Interactive comment on “Can we trust remote sensing ET products over Africa?” by Imeshi Weerasinghe et al.

Imeshi Weerasinghe et al.

Received and published: 23 September 2019

Fig. 2. Percentage bias and basin area weighted bias between the long-term annual average calculated ET_{WB} and ET_{RS} for all basins and the average of the 20 basins.

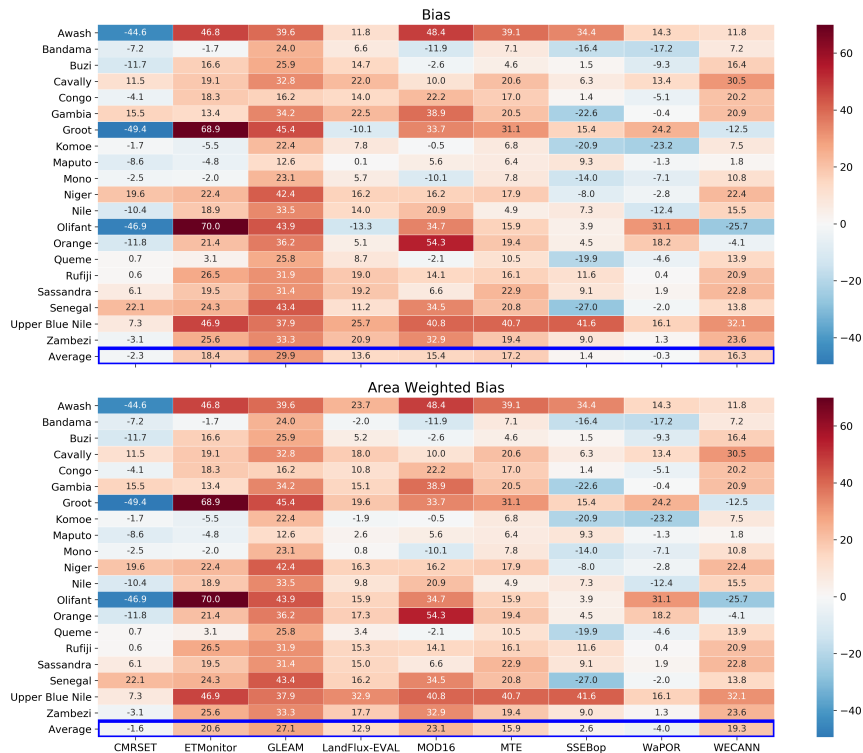
Reviewer 1, Specific Comment 2 Figures 7 and 8 may benefit from one more panel which shows the average of the three precipitation products as the ranking is based on the average the three.

Authors Response We have taken out the statistics based on each different precipitation product and have used the average of the three products after a comparative analysis of the three precipitation products. In this way, instead of including a separate column with the average of the three products in figures 7 and 8, we have included one figure (figure 8) which shows the percentage bias and percentage basin area weighted

bias between calculated water balance ET and ET estimates from products across the basins. This includes positive and negative biases giving an idea of under or over estimation by each product across different basins or the average of all basins. (P5,L23) and Figure 8.

Fig. 3. Spatial assessment across Africa of each ET product based on selected land cover elements, forest, irrigated areas and water bodies

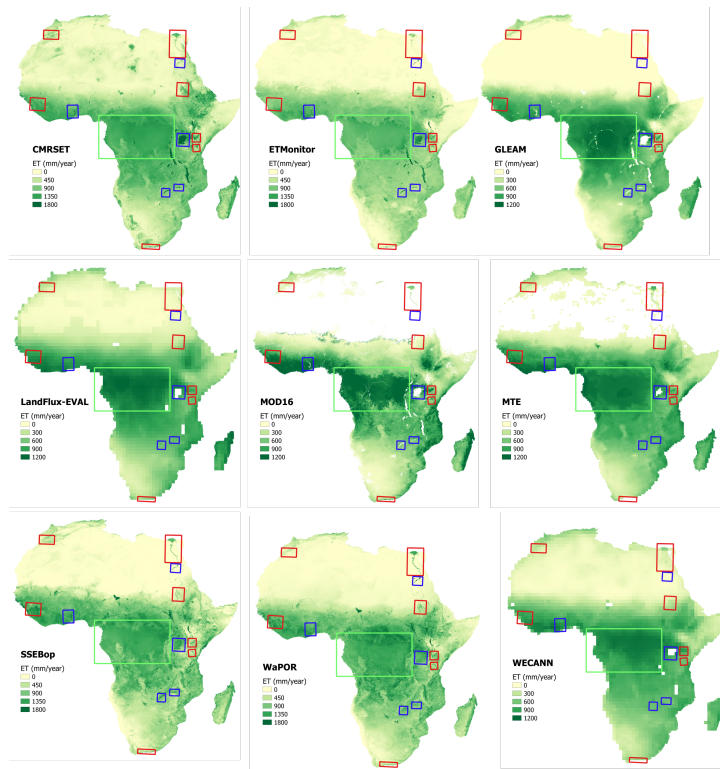
Zoom-in maps: it is hard to see the differences in Figures 9 and 10 among models. Maybe it is better to show deviations from the MPM data, i.e., show MPI in mm but the rest of the models as differences from MPM. Also remove the grid lines, hard to read the maps. A better color ramp will help readability. Authors Response We have not zoomed into a particular area but have looked at the land cover elements with respect to the entire continent. The colour ramp used is now clearer between the selected land cover elements and each element has been highlight with a box. The multi-product mean (MPM) was not used anymore as for the multi-product we used a different existing product. This was used instead of calculated the MPM from our products due to a comment by another review which asked to look at a weighting system for its calculation which was not in the scope of this study. (Figure 10) Authors Changes in Manuscript

Reviewer 2, Specific Comment 6 – Methodology and results The ranking of products based on visual inspection is rather speculative for me. For ex on Fig 9 it was impossible to follow the text conclusions: I did not see where irrigation C7 HESSD Interactive comment Printer-friendly version Discussion paper area is, to which reference product other products are compared, why MPM and some other products have no data and why GLEAM is concluded to perform worst? The same for Fig 10..

Authors Response We re-did this section to include forest as an additional land cover type for inspection as well as using highlighted areas across the entire African continent rather than zooming into selected areas shown in figure 5. We agree that this is a rather subjective method, however, we also believe it is relatively visible to see the difference between the products especially when using different scales to be able to visually interpret the results. We believe these maps are an added advantage for reader interested in spatial characteristics of ET. However, due to its potential subjectivity in ranking, we do two final rankings, with and without visual inspection to minimise this subjectivity. (P13,L4), (Figure 10) Authors Changes in Manuscript “Figure 10 shows ET across Africa for all ET products with the specific land cover elements (forest, irrigated areas and water bodies) highlighted. Two different scales are used in order to be able to visually compare the products according to spatial variability rather than magnitude of ET. For products where large biases were found, a scale of 0-1200 mm/year was used and for the remaining products a scale of 0-1800 mm/year was used. Visually, all products capture the forested area. Irrigated areas are also captured well by most products. GLEAM and LandFlux-EVAL do not capture the majority of selected irrigated areas. CMRSET, ETMonitor, SSEBop and WaPOR capture most of the selected irrigated areas while the remaining products capture a few. GLEAM, LandFlux-EVAL, MOD16, MTE and WECANN only estimate land ET and thus do not have ET across water bodies. The remaining products capture the water bodies well, with CMRSET and ETMonitor showing larger differences in their estimations of ET across water bod-

ies than the surrounding areas over SSEBop and WaPOR.”

Fig. 6. Comparison of the EWEMBI, CHIRPS and MSWEP precipitation products on their prediction of mean P across the basins

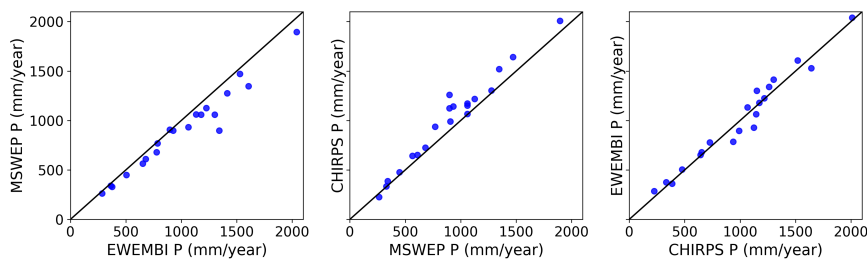
Reviewer 2, Specific Comment 3 – Scientific Relevance The study does not mention anything at all about the quality of the reference precipitation data sets, nor about the quality of the final WB- based ET product. The study should also provide or mention some quantitative assessment to the magnitude of the differences which arise only due to application of different rainfall products. This will (i) - substantiate introduction of three different rainfall products in the paper and (ii) – justify better the obtained differences in ET between the products. Authors Response We have now used the average of the three precipitation products due to only slight differences found in the calculated mean precipitation between the three products also considering that we use the average of the three products for ranking purposes. The comparison between the three precipitation products have been included in the paper. We have also tried to evaluate the reasons behind the differences between the ET products within the conclusion. This was already mentioned somewhat in the discussion (P5,L23), (P9,L25), (Figure 5), (P20,L15). Authors Changes in Manuscript

“Precipitation and potential evapotranspiration were taken as the average of three products. Here we compare the results of the different P and PET products for the basins being analysed. We see that the three precipitation products show little differences in their estimations of long-term average P across the basins. No large outliers can be seen (Figure 5).”
